UNITED STATES PATENT AND TRADEMARK OFFICE

APPLICATION NO.	FILING DATE	FIRST NAMED INVENTOR	ATTORNEY DOCKET NO.	CONFIRMATION NO.
10/692,487	10/27/2003	Kent J. Myers	KMY.P.0003	1972
7590 06/16/2004			EXAMINER	
Mark L. Weber Renner, Kenner, Greive, Bobak, Taylor & Weber First National Tower Fourth Floor Akron, OH 44308			NGUYEN, PHONG H	
			ART UNIT	PAPER NUMBER
			3724	
DATE MAILED: 06/16/2004

Office Action Summary

DETAILED ACTION

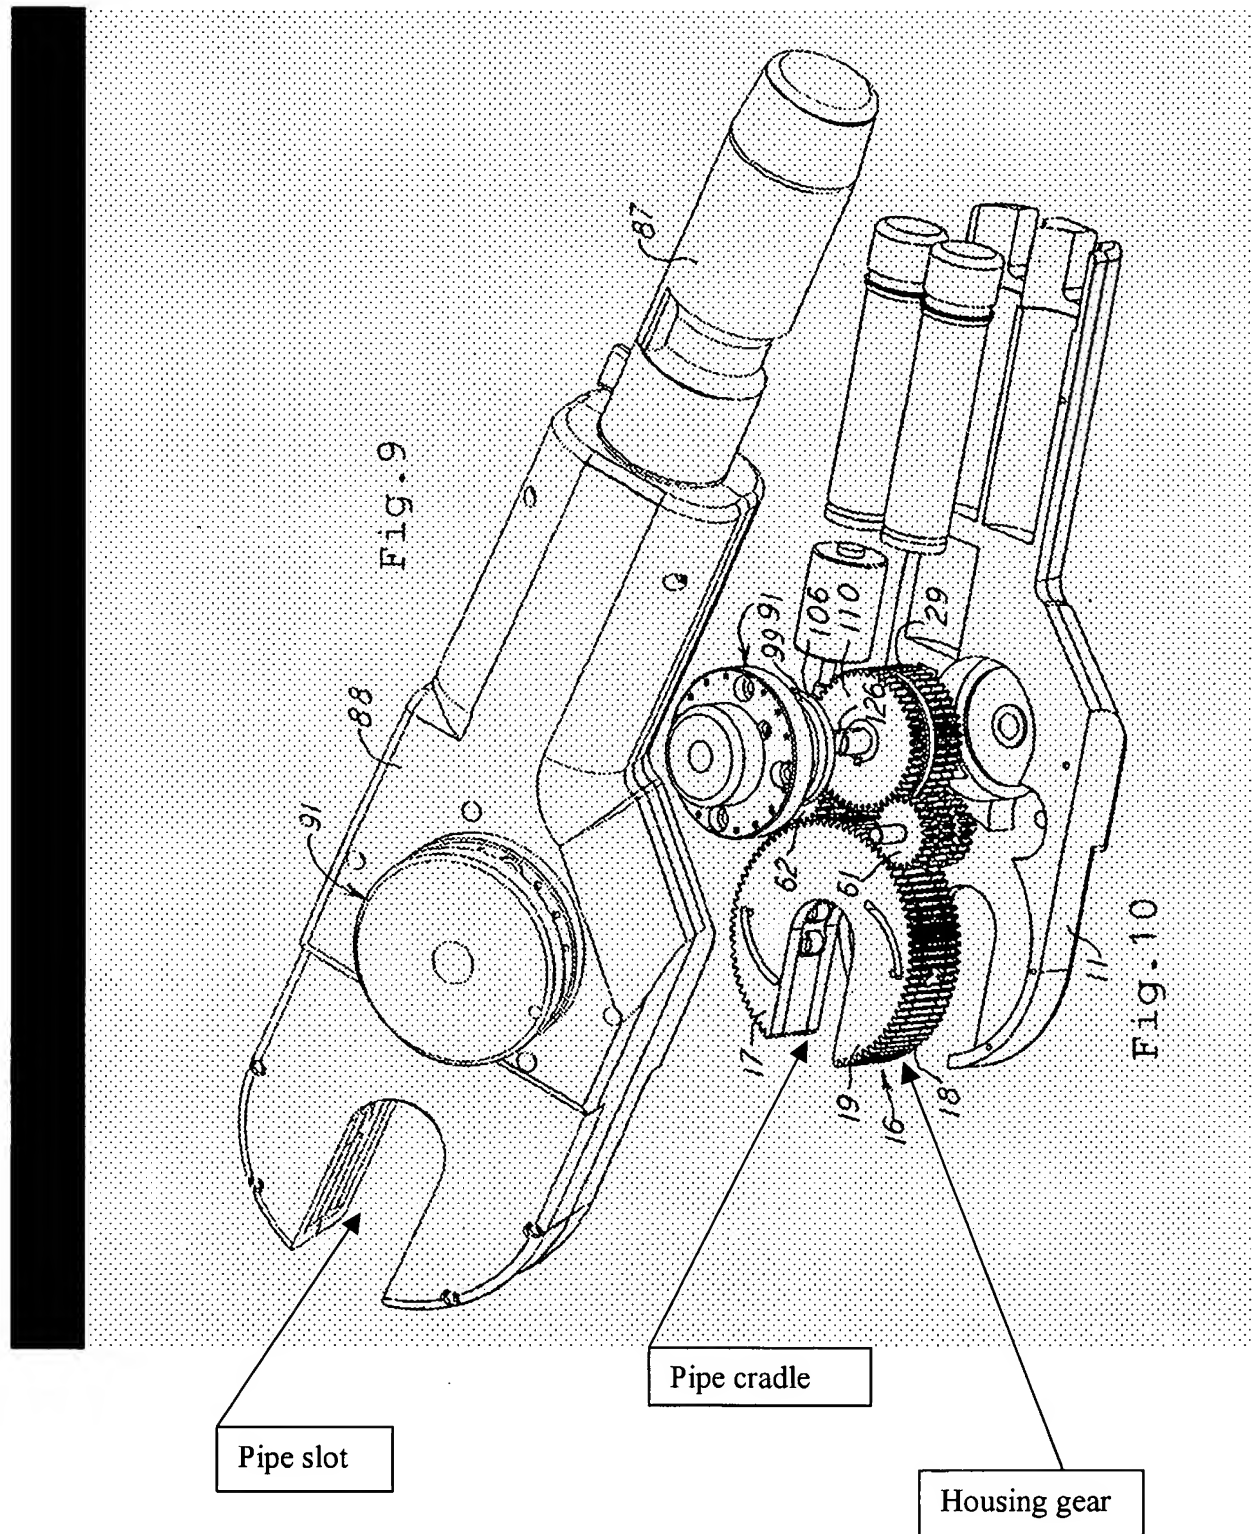
Regarding claims 1-3 and 16, Lazarevic (6,065,212) teaches all the recited elements of the invention including a pipe cutter device comprising a rotary head 16, a housing gear, a pipe slot, a pipe cradle, a cutting wheel 37, wheel biasing members 57

and 59, a drive source 26 and a gear system comprising a prime gear 64, a first drive gear 61 and a second drive gear 62. See Figs. 1-18.

Regarding claim 4, a slot-engaging gear 31 is best seen in Fig. 1. The teeth of the gears are considered as protrusions. During the rotation of gear 31 and the housing gear, the protrusions engage the pipe slot.

Regarding claim 13, two freewheeling support rollers 52 are best seen in Figs. 6, 11, 16 and 18.

Regarding claim 14, an adjustable block 46 is best seen in Fig. 11.

Regarding claim 15, pipe-engage-surfaces 52 are best seen in Fig. 11, 16 and 18.

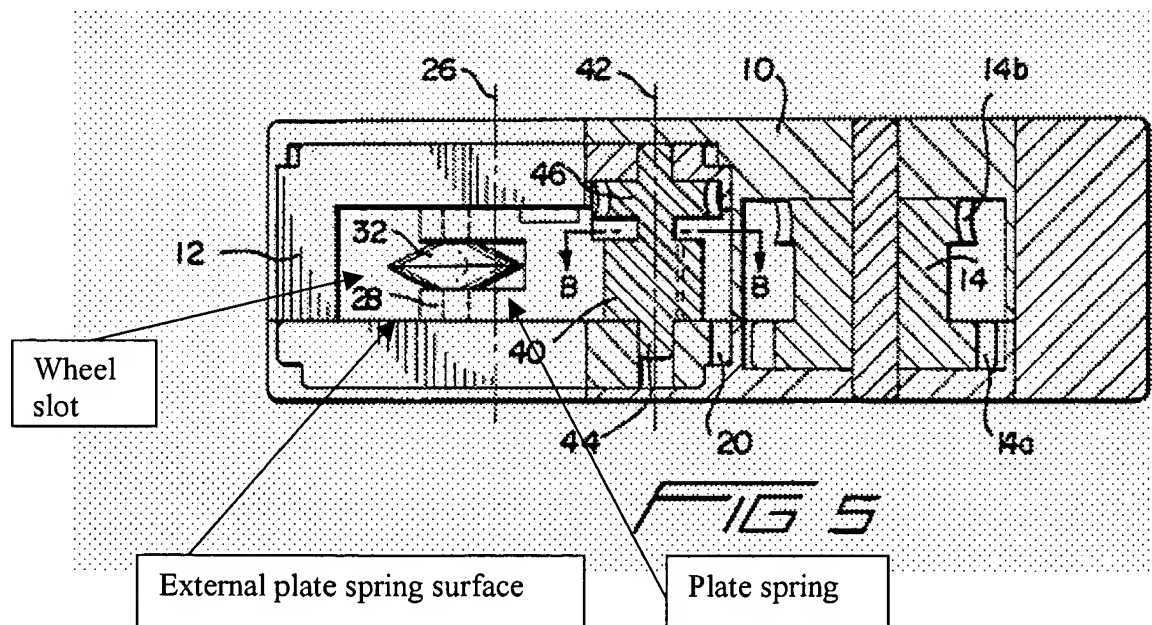
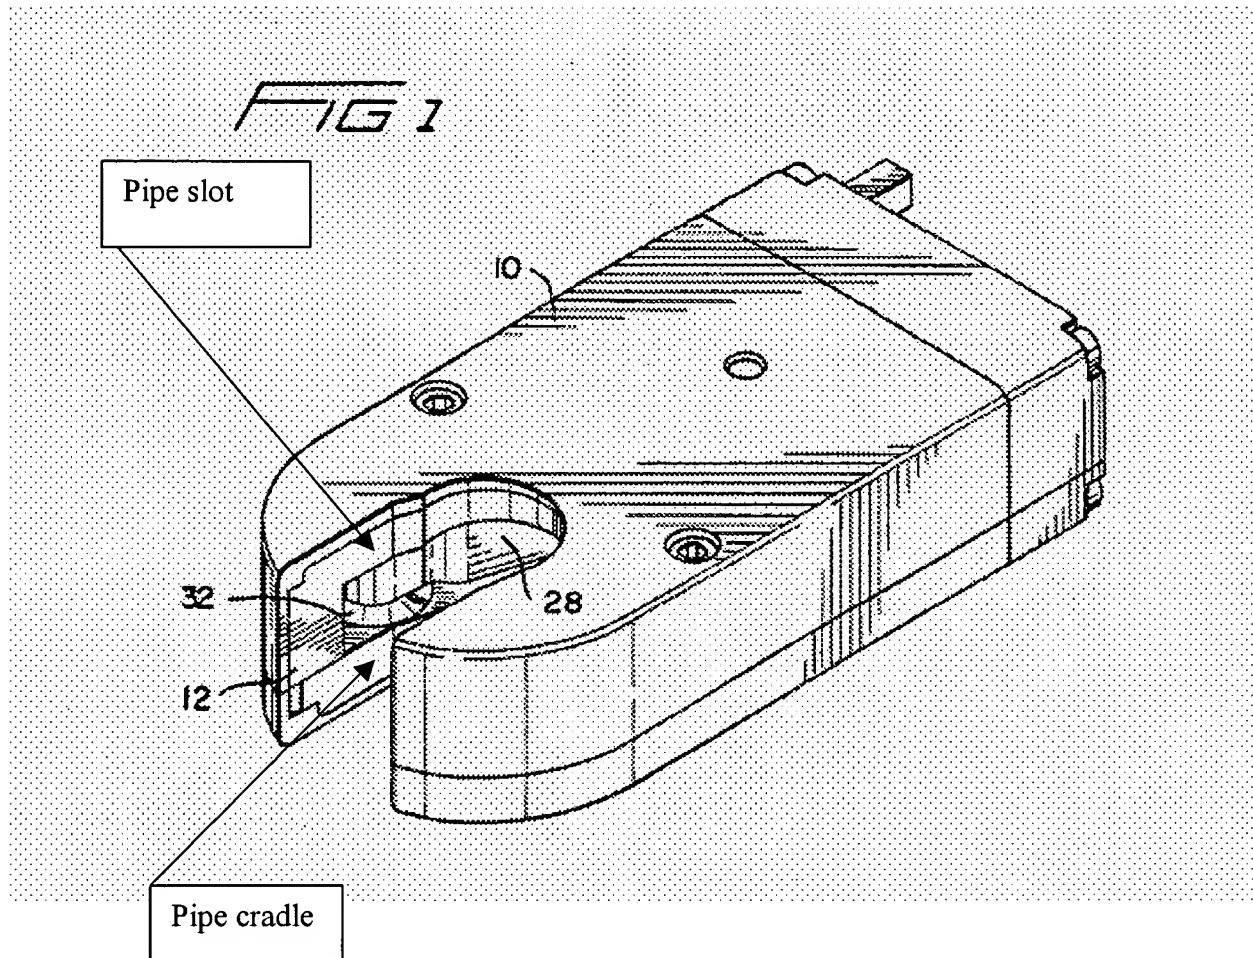
Regarding claims 1-4 and 16, VanderPol et al. teach all the recited elements of the invention including a pipe cutter device comprising a rotary head 12, a housing gear 20, a pipe slot, a pipe cradle, a cutting wheel 32, a wheel biasing member comprising elements 28, 30 and 36 and a drive source inherently in the pipe cutting assembly. See Figs. 1-8.

A slot-engaging gear comprising gears 16 and 18 is best seen in Fig. 3. The teeth of gears 16 and 18 are considered as protrusions. During the rotation of gears 16 and 18 and the housing gear 20, the protrusions engage the pipe slot.

Regarding claims 5, 6 and 7, the wheel-biasing member comprising two plates 28 to form a slot therein for receiving the cutting wheel and the spring 28 for disengaging the cutting wheel from the pipe is considered as a plate spring member since it performs the same claimed functions. The plates 28 support the freewheeling shaft of the cutting wheel and the spring 28 urges the freewheeling shaft via the plates 28. See Figs. 2, 4 and 5.

Regarding claim 10, the spatial relationship of the rotary head and the plate spring member is best seen in Fig. 5.
